Product/Process Change Notice (PCN)

PCN #: WE_LQS_20160913

Product Affected: WE-LQS size 2512 series

PCN Date: September 13th 2016

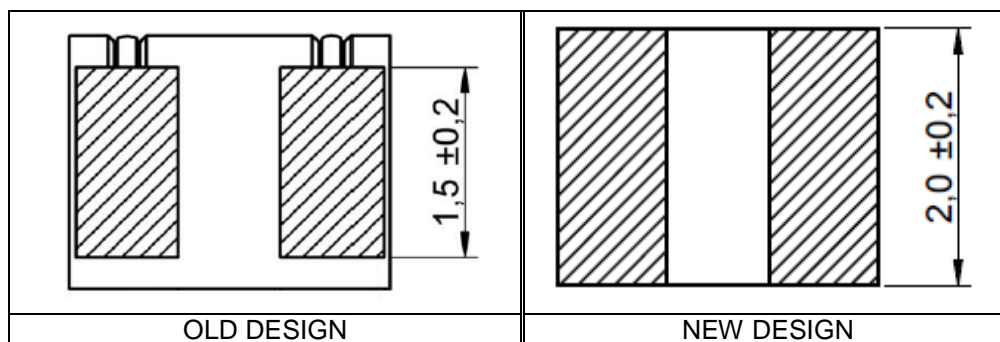
To improve the Quality of the soldering process, the dimension of the plated electrodes have been modified for a better stability at customer applications.

The Dimension of the electrode has been increased from 1.5 mm to 2.0 mm. At the next figure we see in detail the change:
